28F400BX/BL
28F004BX/BL
28F200BX/BL
28F002BX/BL

SPECIFICATION UPDATE

Release Date: July 1996

Order Number 297187-008

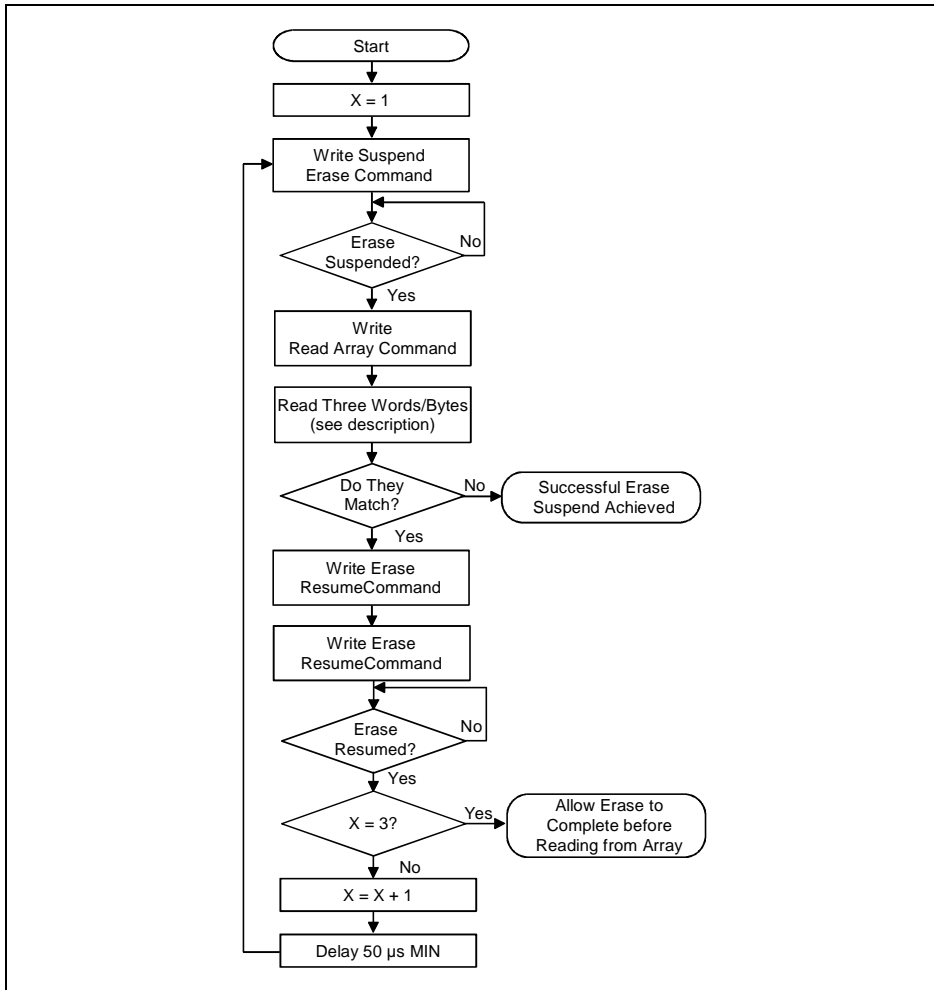
PROBLEM: The 28F400/004/200/002BX/BL enter erase suspend mode when the Erase Suspend command is written to it (while the internal Write State Machine is executing an internal erase algorithm). Polling the Status Register and RY/BY# output will signal to the system that Erase Suspend has occurred. The device is now in erase suspend to status mode and writing the Read Array command will, **in most instances**, signal the device to output array data when read. The device enters a mode referred to as “erase suspend to array.” This allows system software to execute code or read data from blocks of the device.

Affected components in erase suspend to array mode will occasionally, after the Read Array command is written to them, output invalid array data due to an error in the State Machine circuitry. The device in this instance enters an invalid erase suspend mode and outputs invalid data bytes. Statistically, this has occurred approximately once every 500 erase suspend attempts.

It is important to note that even if the device is in an invalid erase suspend mode, writing the Read Status Register command will still enable transition to erase suspend to status mode and subsequent reading of Status Register data correctly. This erratum only affects array read attempts while erase is suspended.

Erratum Identification/Resolution

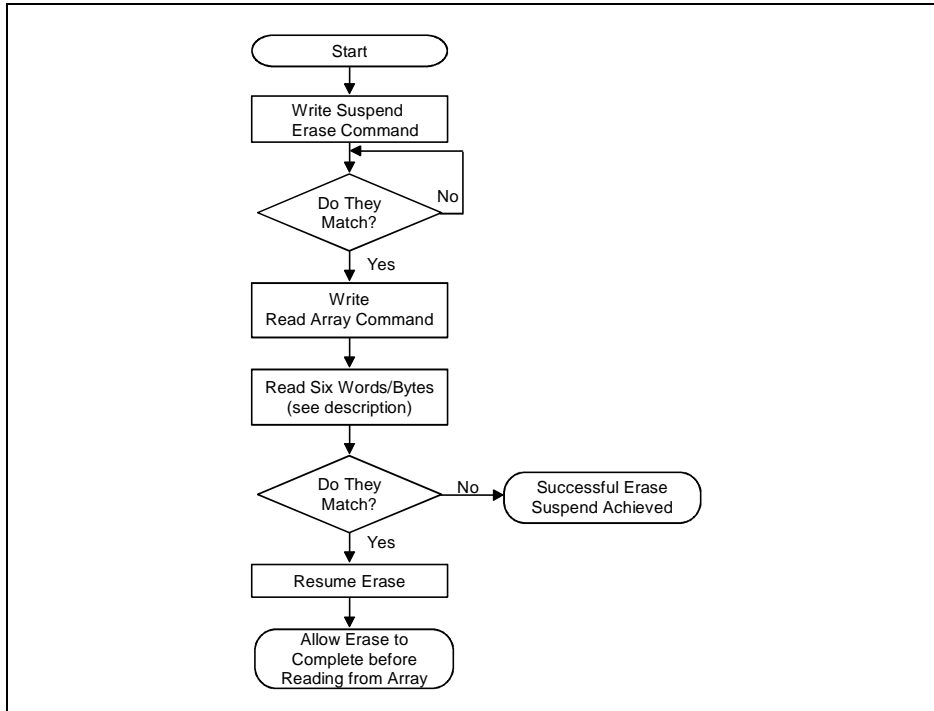
WORKAROUND: The following procedure will reliably and consistently alert system software that the devices listed above have entered the invalid erase suspend mode. In almost all cases, this solution will also enable successful erase suspend. Reference the flowchart, *Erratum Identification/Resolution*, which follows, for a graphical description of the steps outlined:

Process:

- I. Write the Erase Suspend command to the device.
- II. Poll the Status Register to determine when Erase Suspend has been achieved.
- III. Write the Read Array command to the device.

- IV. Read three words/bytes of data from a block **other than that being erased**.
 - A. At least one of the three words/bytes should have a **known different value** compared to the other two. You must know that at least one of these words/bytes are different from the other two before writing the Erase Suspend command to the device. This can be determined by reading the device in normal read array mode.

- V. If the values at these three locations **do not** match (as expected, because one of the words/bytes was determined to be different from the other two, before writing the Erase Suspend command), erase suspend to array mode has been entered successfully.

- VI. If the values at these three locations match, erase suspend to array mode has not been entered successfully on this attempt. Instead, the invalid erase suspend mode has been entered. Write the Erase Resume command to the device.
- VII. Read the device outputs (poll the Status Register) to determine when erase resumption has been achieved.
- VIII. Wait 50 μ s.
- IX. Re-execute the erase suspend attempt up to two more times (or three times total).
- X. If not successful after three attempts, issue the Erase Resume command, and allow the internal erase algorithm to complete before attempting to read from the array.

Using RP# for Protection against Spurious Command Writes

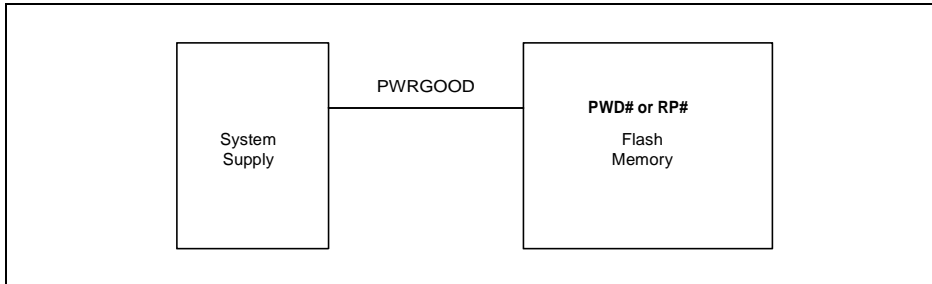
To provide total protection from spurious writes, however, Intel recommends using the deep power-down/reset pin, RP#, to disable the flash memory during V_{CC} power transitions or reset operations.

To implement RP# write protection, RP# should be connected as shown in the figure below. The powergood (PWRGOOD) signal, available on most system supplies, goes low (active) when V_{CC} is removed from the system. When this occurs, RP# is forced low, the flash state machine is reset and the flash enters deep power-down mode where the flash is disabled regardless of the state of the other control pins. Upon V_{CC} power-up the power-good signal, and hence RP#, is forced high and the flash transitions to read array mode.

Pin Identification

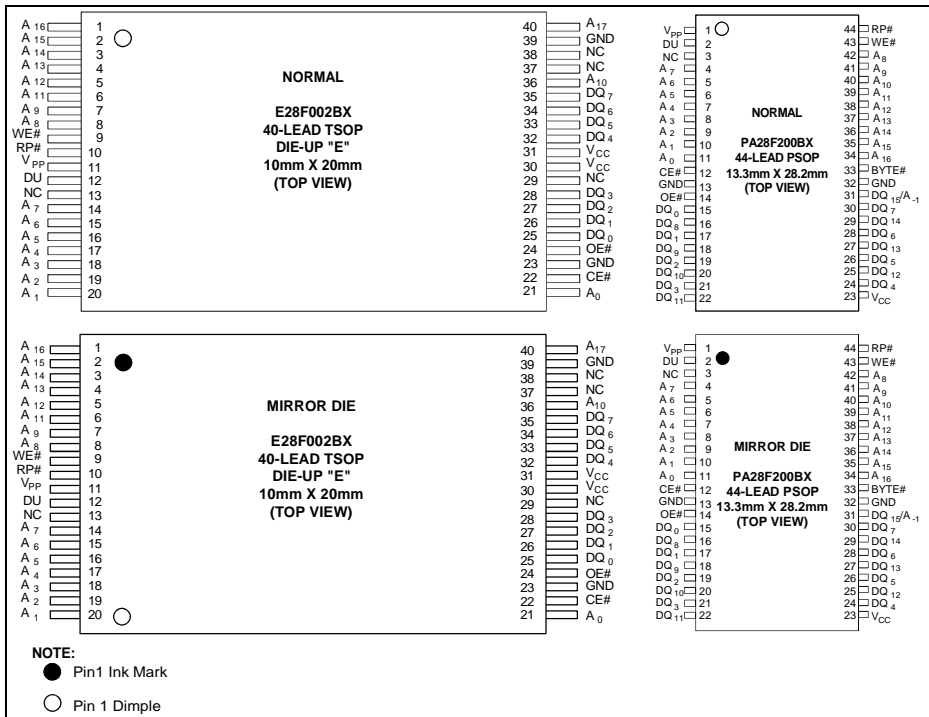
PROBLEM: The die from the first few lots of the 28F200/002BX 2-Mbit Boot Block flash memory were mirror-imaged. These mirrored die have been qualified and found to be identical in every way to subsequent normal devices. However, some package markings had to be altered to identify this difference.

The 28F200/002BX is offered in the die-up TSOP and PSOP packages. Affected materials include both the 40-lead TSOP and the 44-lead PSOP packages. After some testing and package assessment, the mirrored die was inversely placed (i.e., built as die-down) in the die-up packages. A white dot is painted on the top, near the left-hand corner to indicate the position of pin 1. The distinguishing characteristics of these different package types are explained in the *Pin Identification* figure below.
